EPA-AA-TEB-511-82-11

**EPA Evaluation of the Dynamix Device Under Section 511
of the Motor Vehicle Information and Cost Savings Act**

August 1982

**Test and Evaluation Branch
Emission Control Technology Division
Office of Mobile Sources
U.S. Environmental Protection Agency**

Figure 2 Proportioning Valve

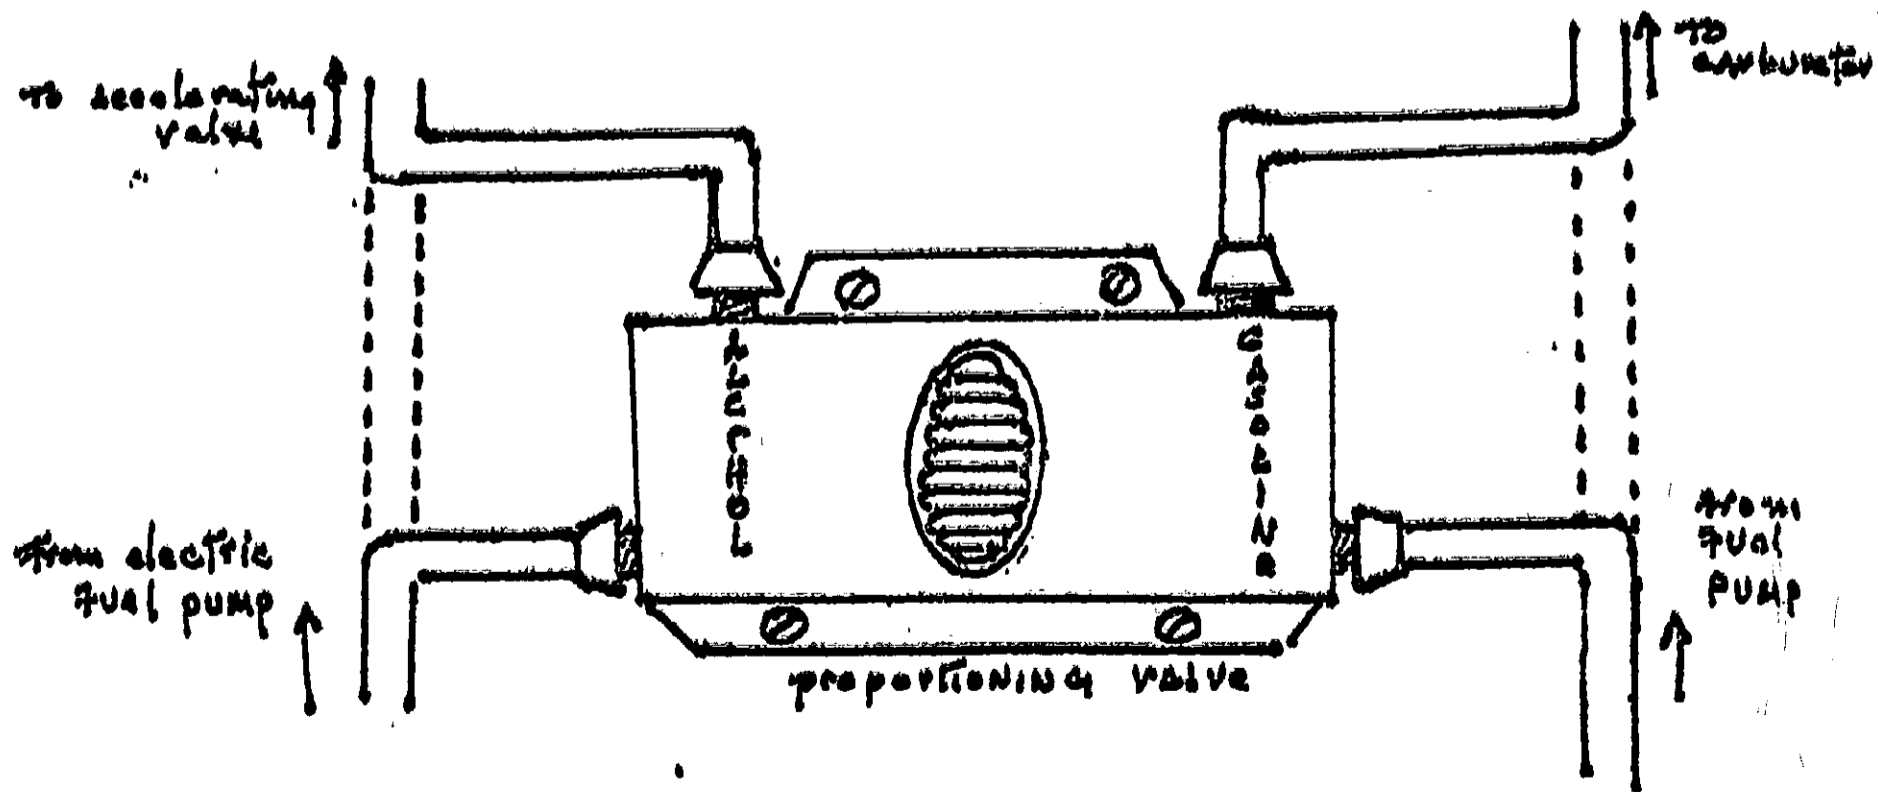
The description of the proportioning valve is not sufficient to show that it is actually able to function as claimed. The description does not specify how the device is able to control the flow of gasoline to be a fixed percentage (i.e., flow ratio) of the alcohol flow and how this flow ratio is readily adjustable by the operator.

- B. The drawings of the proportioning valve, provided as an attachment to your letter, do not adequately describe the valve and its manner of operation. Please provide a more detailed description of the valve and its method of controlling the flows of ethanol and gasoline.

Figure 3 Accelerator Valve and Linkage

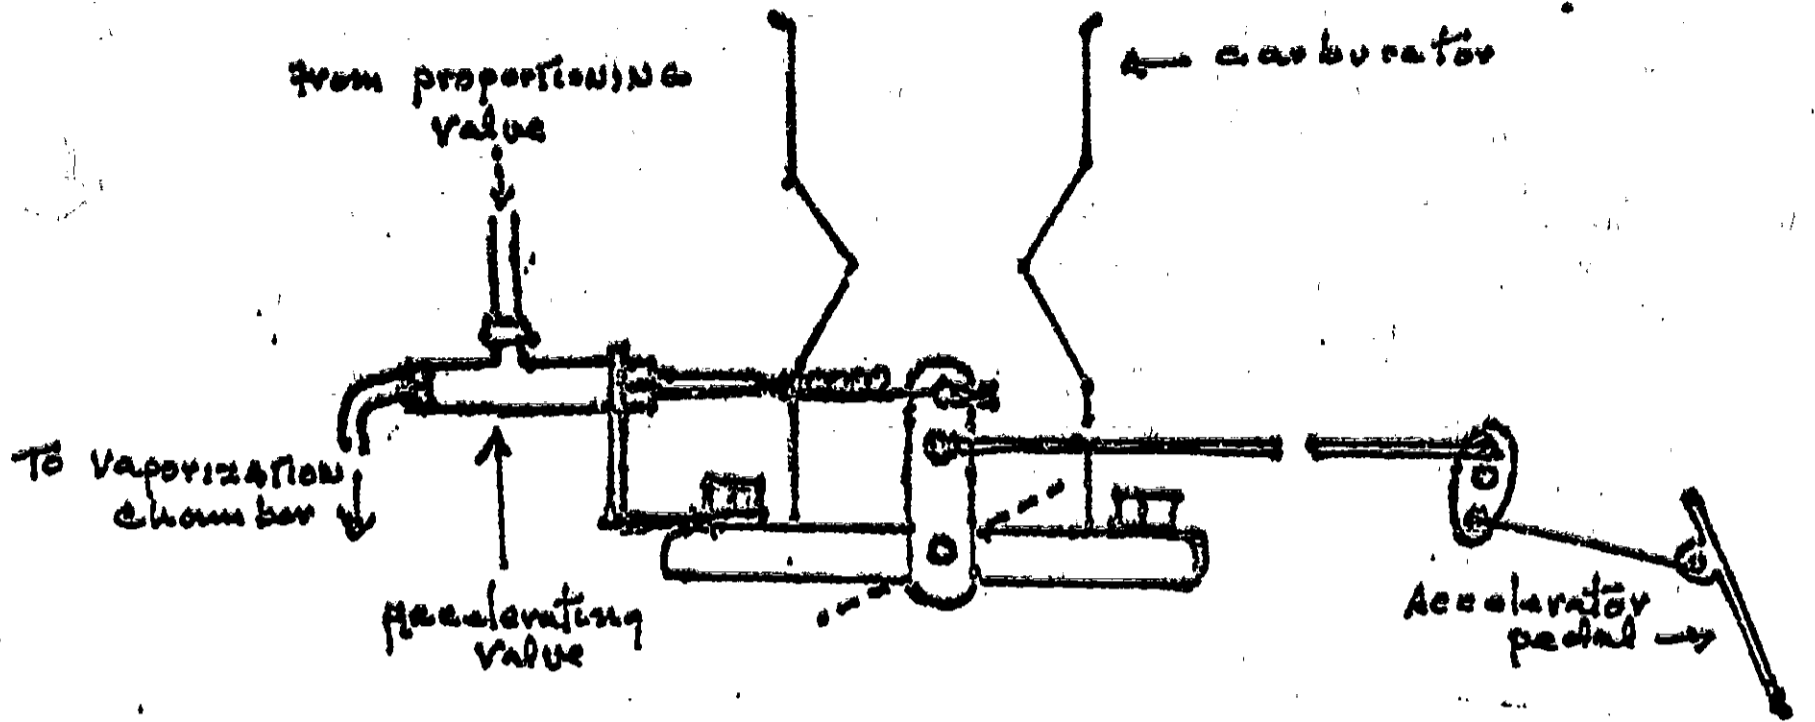
The description of the "accelerating valve" was also inadequate. Although it was called an accelerating valve, it appears to be more properly an alcohol flow control valve that is opened and closed by the throttle linkage. It does not replace the function of the carburetor accelerator pump. The functioning of this valve is also questionable. The linkage adjustment procedures instruct the installer to adjust this valve so that it is shut off at idle and is open at engine red-line (while in gear) sufficiently to control the alcohol flow to be the desired alcohol/gasoline fuel ratio. Therefore, the alcohol flow is controlled to be a function of throttle position only, regardless of engine load, whereas, in an unmodified engine, gasoline flow is controlled to be a function of both load and rpm. Thus the engine could have either too much or too little of this gasoline/alcohol blend under all operating conditions.

Figure 4 Vaporization Chamber

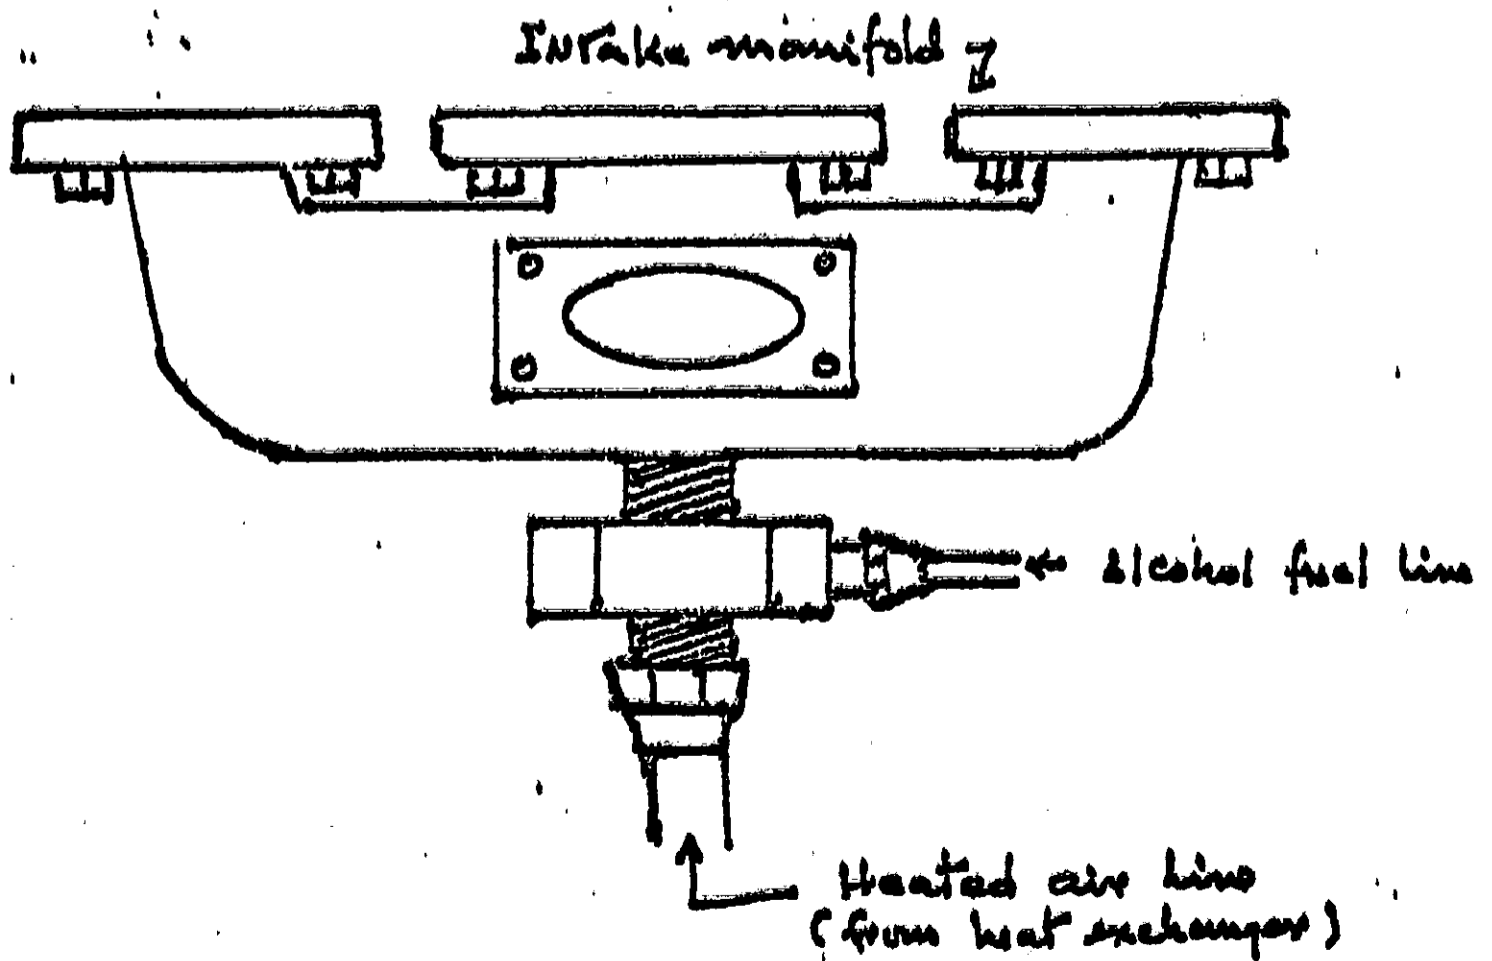
The vaporized alcohol is introduced at any convenient hole in the intake manifold. This will cause uneven fuel distribution to the various cylinders if either the hole is not centrally located or there is uneven mixing of the vaporized alcohol and gasoline. EPA asked the applicant to comment on this mixing problem (Attachment D). The applicant's response indicated that he was aware of the problem and now uses a carburetor base plate adapter to allow the vaporized alcohol to be introduced at the center of the intake manifold (Attachment E). This approach will tend to make the fuel mixture more uniform. However, the applicant submitted no information that showed that good mixing and distribution actually occurred.

3. Section IX, F. shows the vaporization chamber located in any convenient orifice in the intake manifold or the manifold PCV hole. It appears that this would not give an identical homogenous mixture of air, hydrous alcohol and gasoline to each cylinder for most vehicles. Please comment and provide data.
4. Section X, I. states that for adjusting the device and vehicle, the gasoline flowrate is taken "at a point just below the red-line of the tachometer while the vehicle is in motion". This adjustment procedure is unacceptable. It would require the vehicle to be operated at maximum speed for an extended period and thus present a safety hazard.

3. You must be referring to the need to effect a fairly equal distribution of air and fuel alcohol to all the cylinders. This is not a problem when the orifice is located in the center of the intake manifold. Most of the popularly sold cars in the PHILIPPINES (RP) have the orifice in the center of the intake manifold. Whenever the orifice in the intake manifold is not centered, we provide an adapter immediately under the carburetor containing an inlet orifice for the device to effect a more equal distribution of fuel alcohol and heated air to all the cylinders.
